MONTGOMERY COUNTY HISTORIC PRESERVATION COMMISSION STAFF REPORT				
Address:	10220 Capitol View Avenue	Meeting D	ate:	1/8/2025
<b>Resource:</b>	1917-1935 Contributing Resource Capitol View Park Historic District	Report Da	ite:	12/31/2024
Applicant:	Skafte Development Group (Augusto Tono, Architect)	Public No	tice:	12/25/2024
Review:	Preliminary Consultation	Staff:		eccah Ballo/ Bruechert
Proposal:	For partial demolition and construction of new	two-story rear	additior	1

**Preliminary Consultation**

### **PROPOSAL**

The applicant proposes to demolish the rear elevation of the house and construct a two-story rear addition.

SITE PLAN

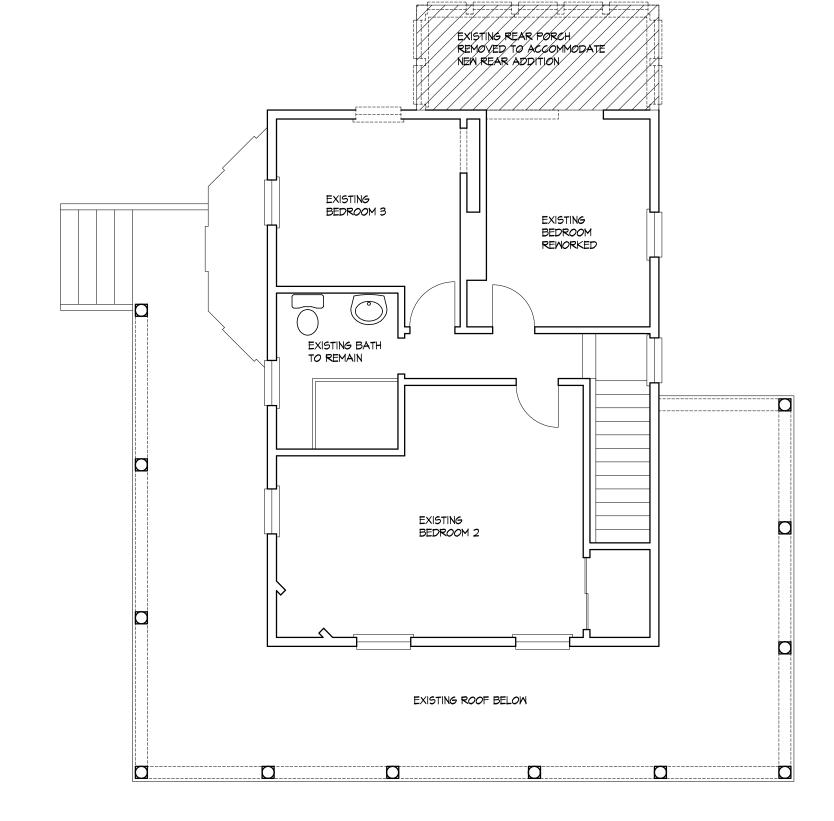
The application notes that no trees will be removed or disturbed by the new construction, but has not provided a tree survey to verify. Staff requests the tree survey for the next submission.

2 PROPOSED FIRST FLOOR PLAN Al scale 1/4"=1'-0"

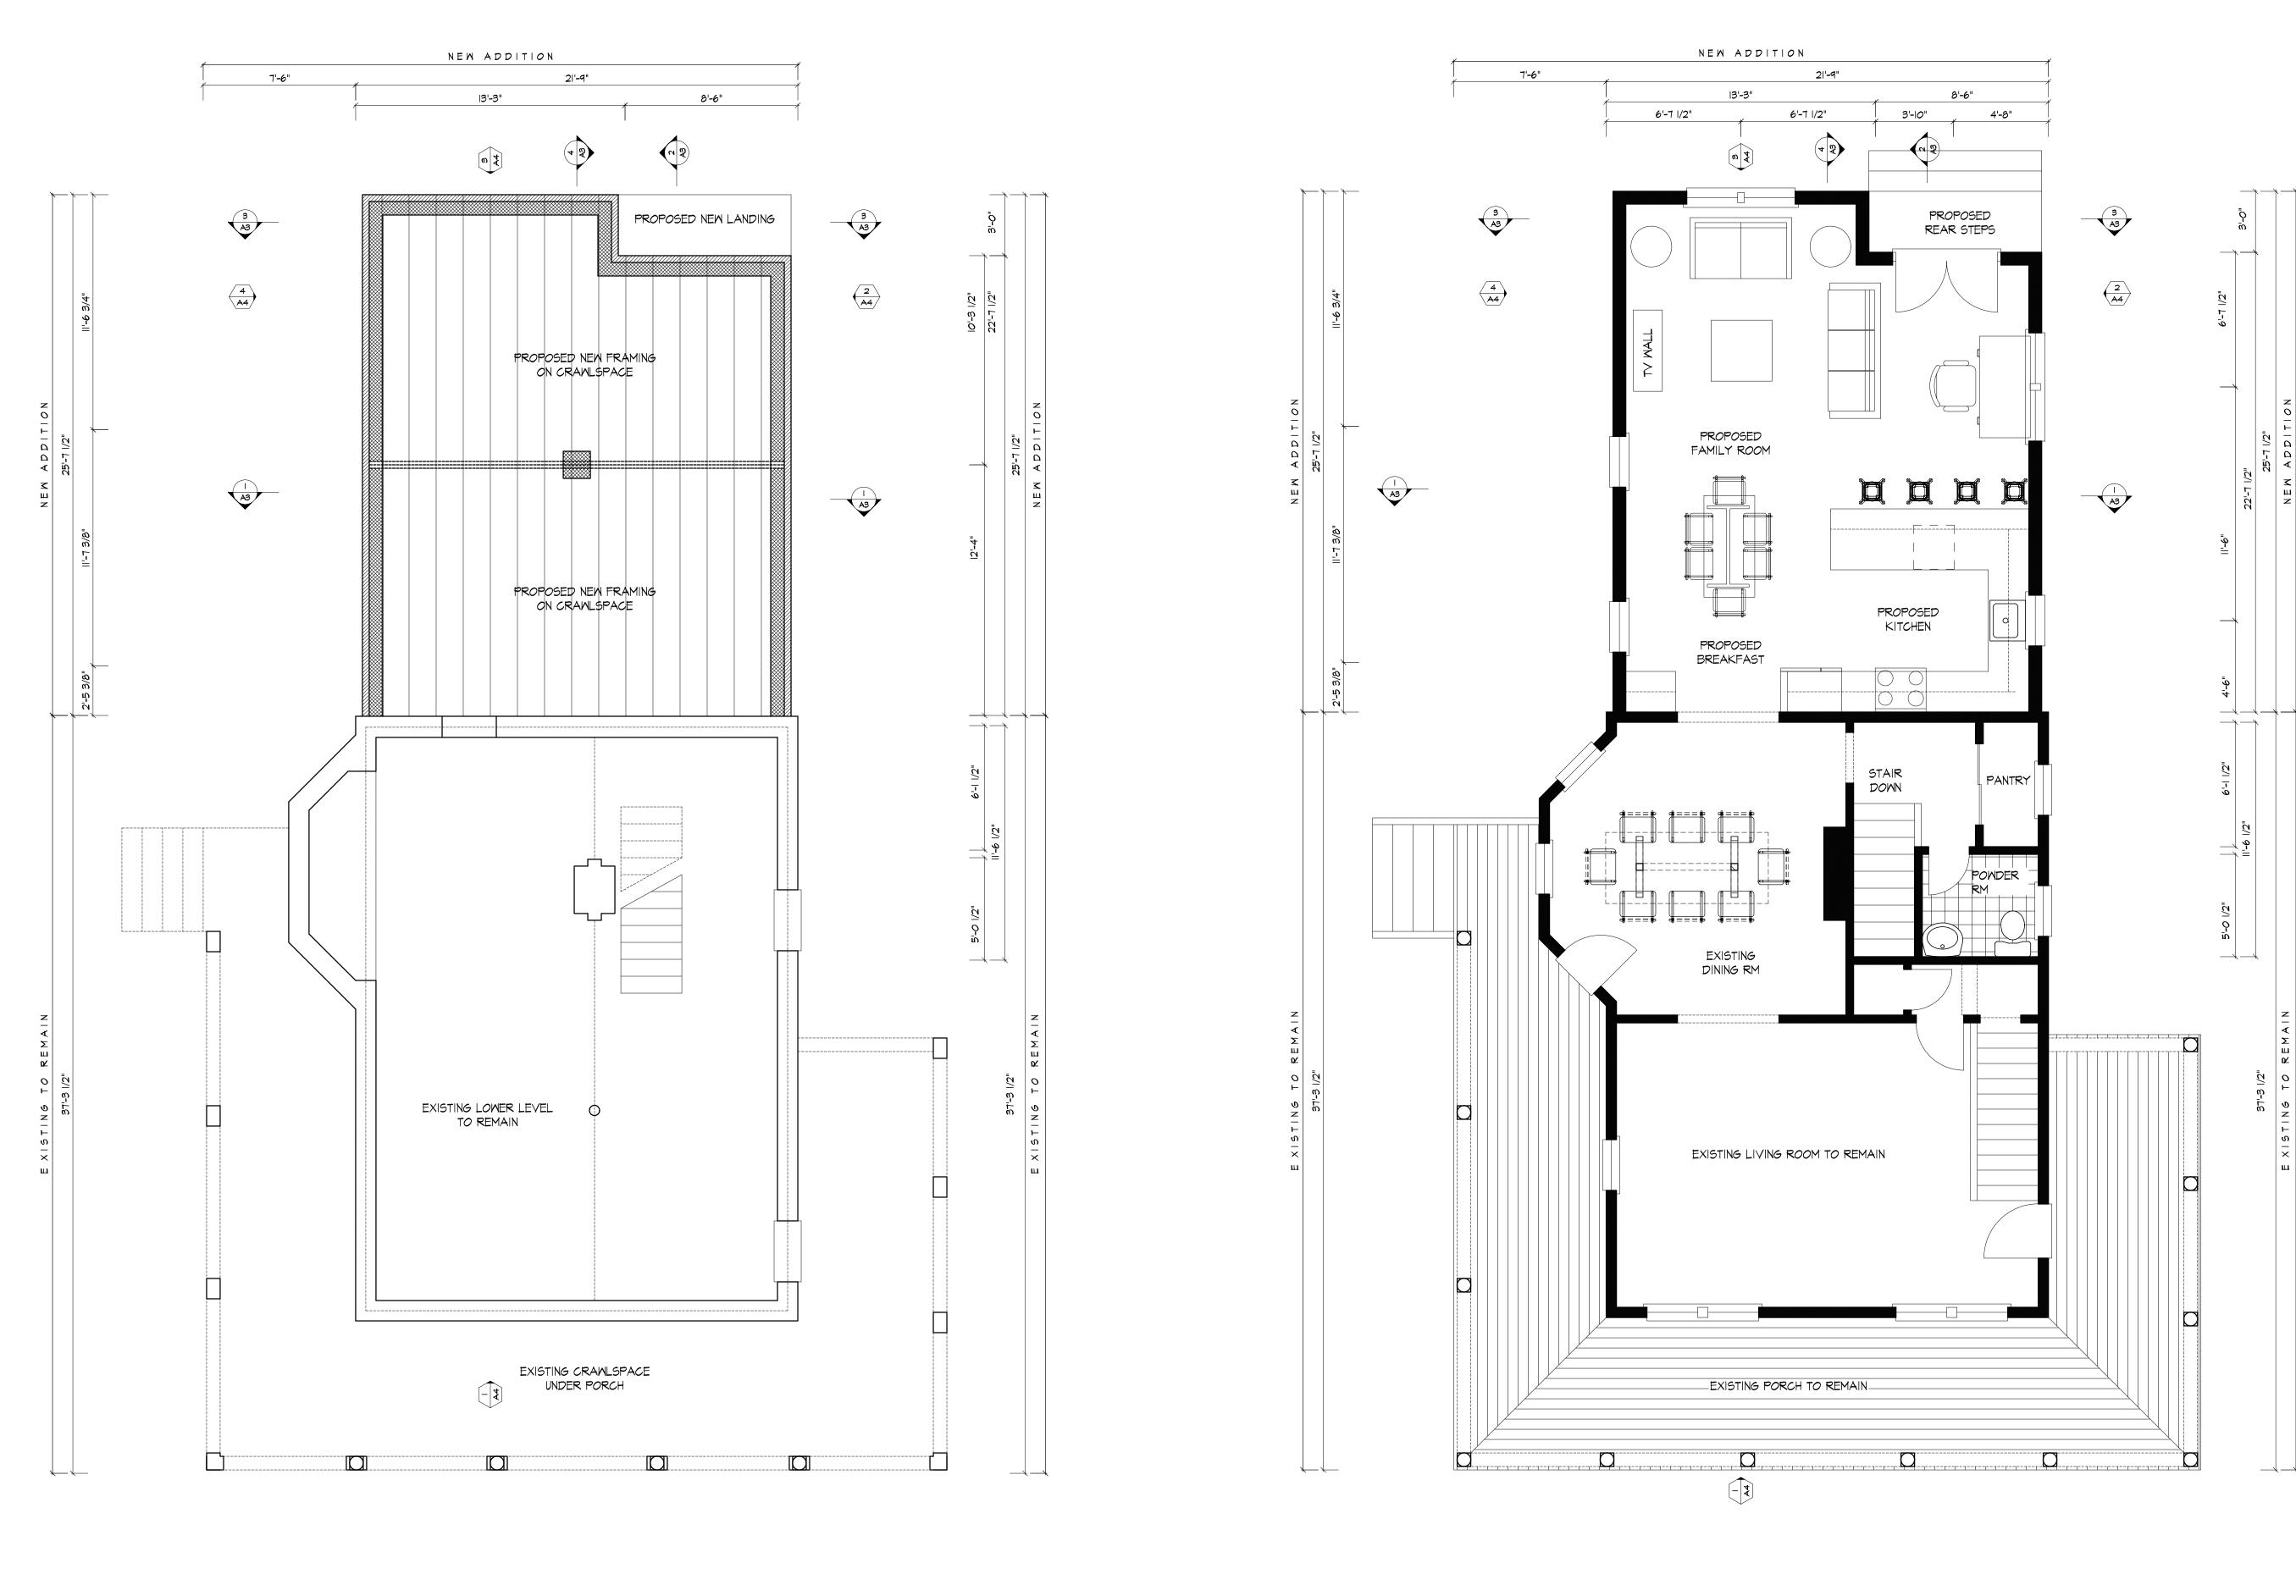
The applicant proposes to construct a new two-story rear addition with an excavated crawl space below. The proposed addition measures approximately 25' 7 ½" long by 21' 9" wide for a total footprint of approximately 557 square feet. The existing house appears to measure approximately 27' long (excluding the depth of the front porch) and approximately 22' wide for a total footprint of the main mass of the house of approximately 594 square feet (note this does not account for the bay window bumpout on the east elevation nor does it account for the square footage cut out for a new rear stoop). Though approximate, the measurements demonstrate that the proposed rear addition measures at least 90% of the square footage of the historic house (the exact calculation is closer to 93.77%). This would effectively double the size of the historic house with the proposed new addition. The applicant is proposing to expand the hipped roof to enclose this new space. While a roof plan with slope calculations was not provided, the plans on A2 and the sections on A3 show that the new roof would engage the existing roof at the same height, with no step down for the new addition. The size of the new addition appears to contravene the *Standards for Rehabilitation: New Exterior Additions to Historic Buildings and Related New Construction;* specifically the standards outlined below in red<sup>1</sup>:

Staff does not find that the size of the proposed addition and the location/height of the new roof adheres to the guidance that it be subordinate and secondary to the mass and scale of the historic building. This finding is enhanced by the minimal setback of the addition from the face of the historic building. While not dimensioned in the drawings, it appears that the new addition is setback less than 4" on each side; the HPC typically requires a minimum 1' setback at each side elevation. Staff recommends the applicant step

A4 SCALE 1/4"=1'-0"

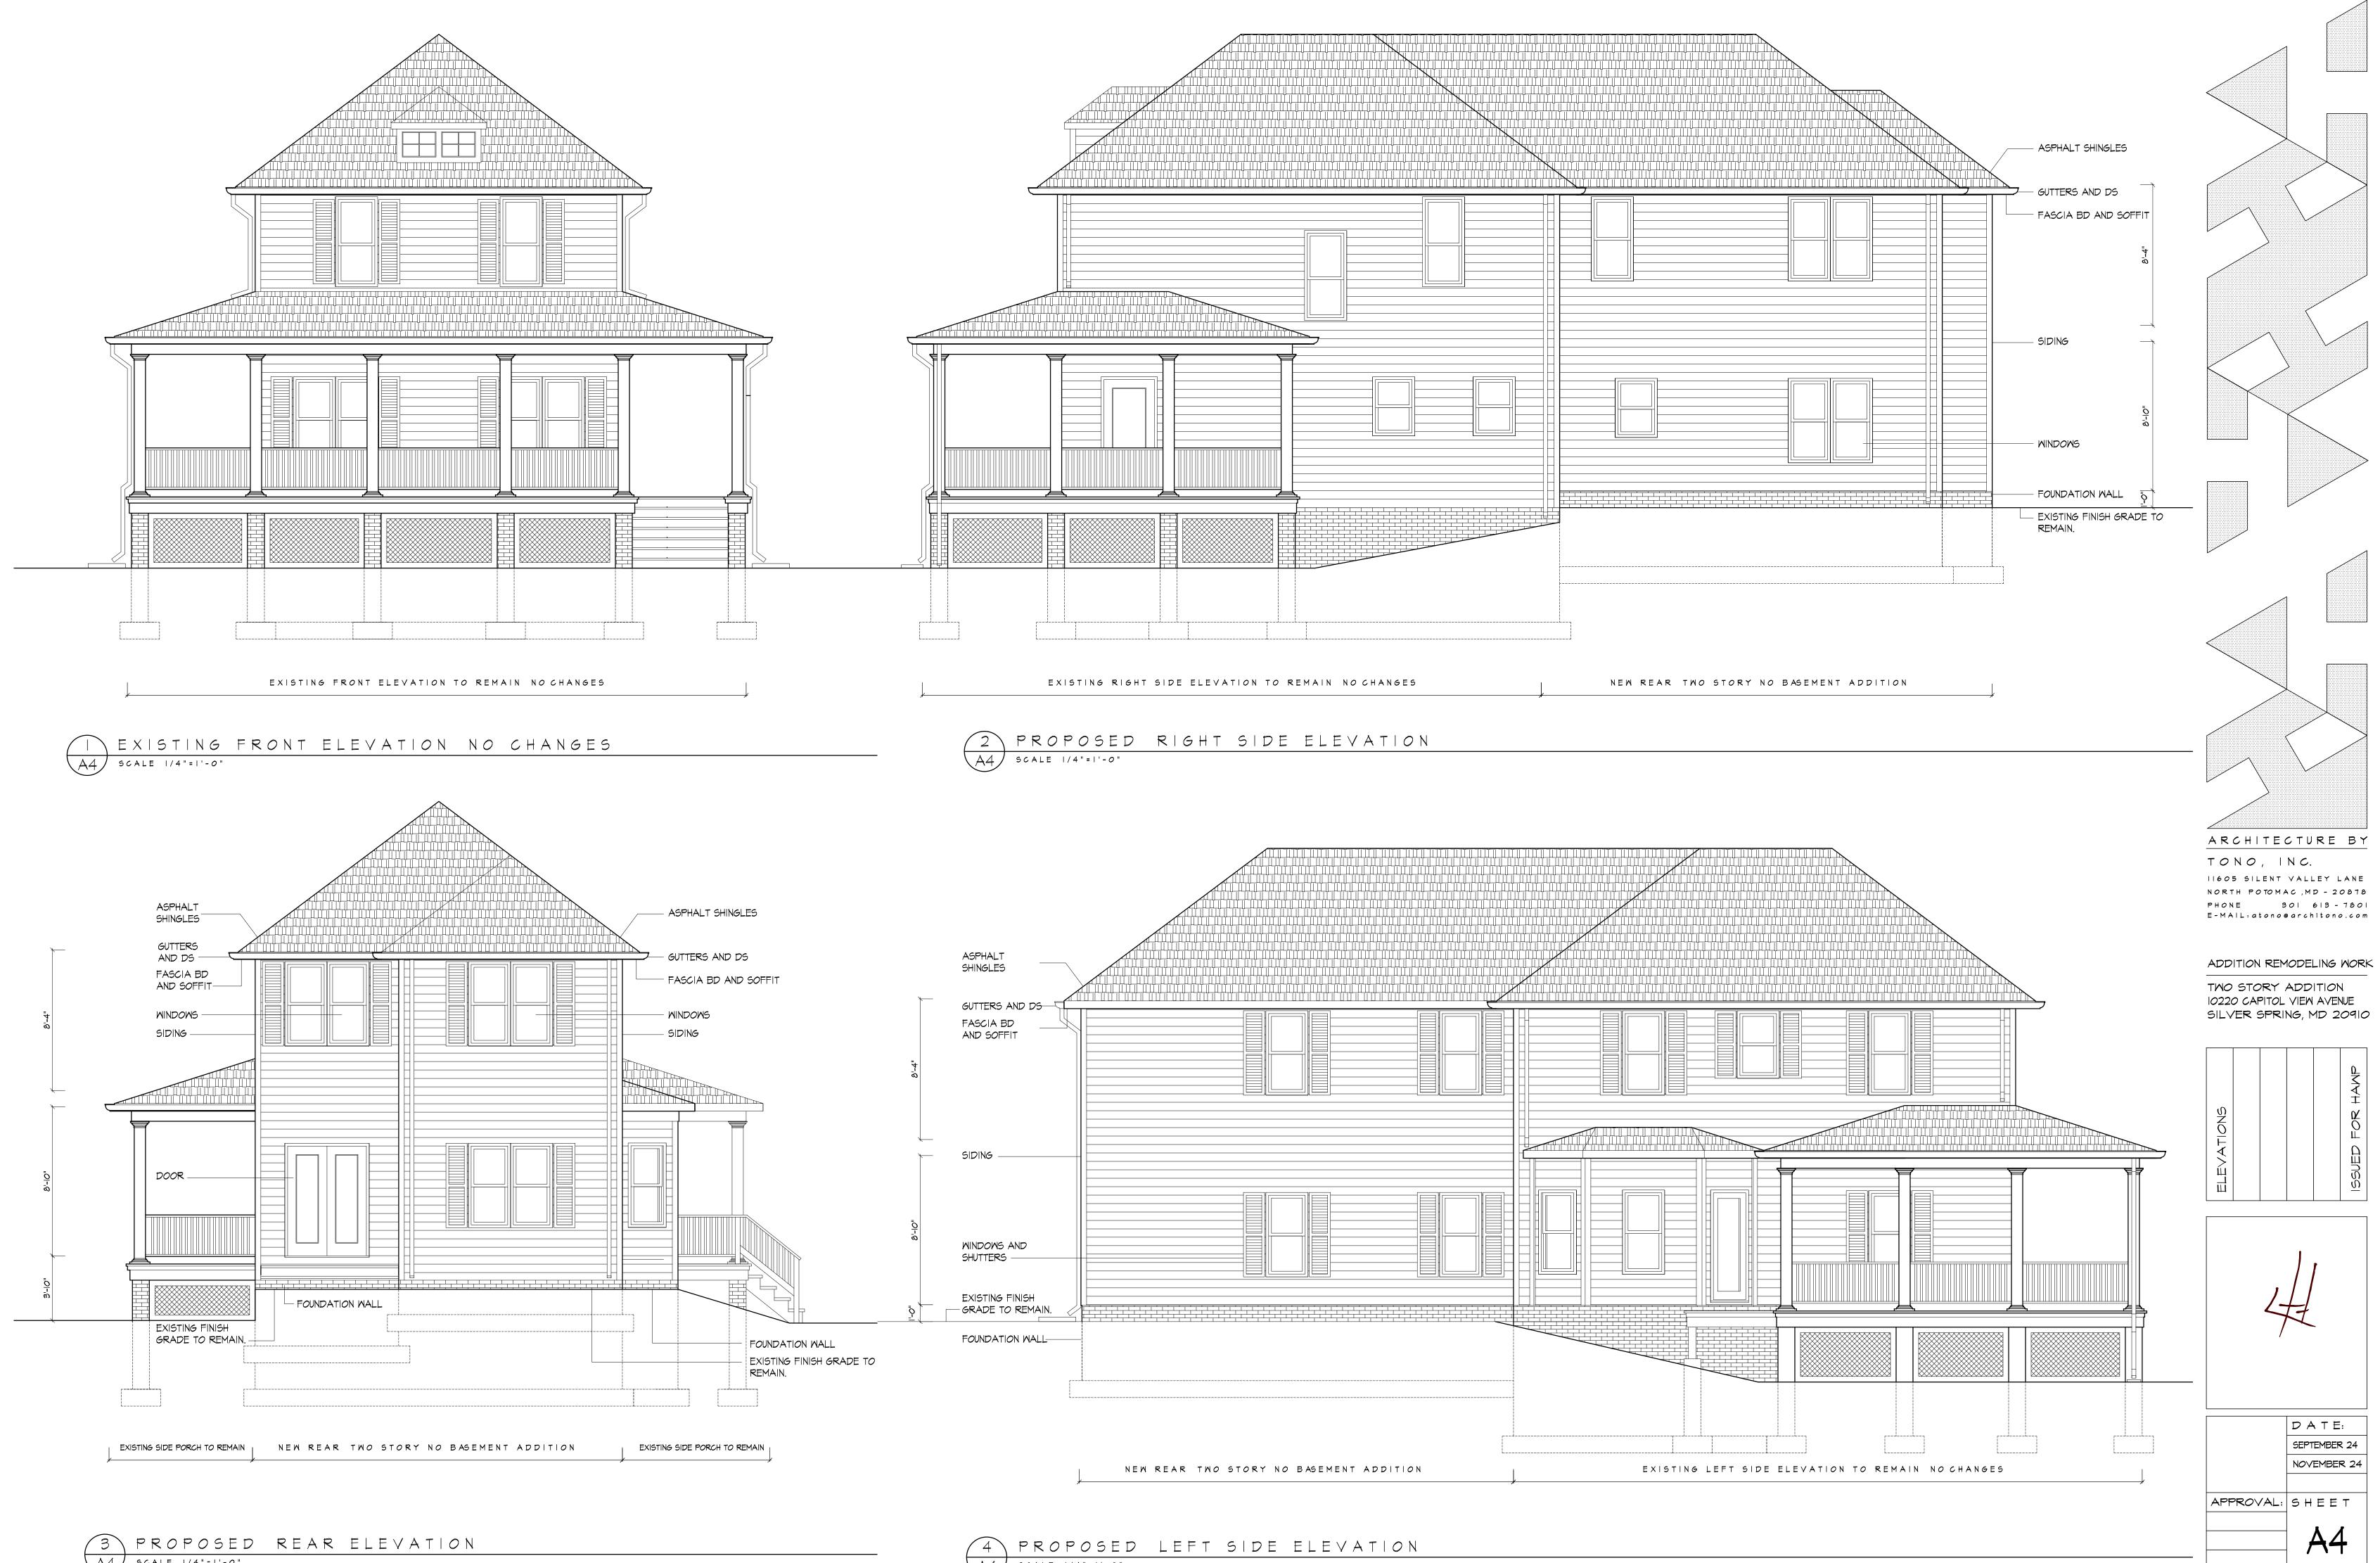
the roof height down a minimum of 1', reduce the length of the addition by 3' - 5', and provide a deeper inset at the side elevations where the historic house meets the new addition.

The design of the new addition proposes a fenestration pattern similar to the existing house, featuring 1/1 windows with shutters, and a simple French patio door on the rear. Staff requests material specifications for the proposed windows, doors, and shutters in the next submission to assess compatibility. Similarly, the new siding appears to match the existing house and the applicants are proposing a brick-faced CMU foundation that would also match the existing house. Full specification information for these features should be provided with the next submission. Staff would also suggest that the profile of the addition on the siding either be 1" wider or 1" narrower than the existing to provide for subtle differentiation between the old and the new per *Standard 9*.
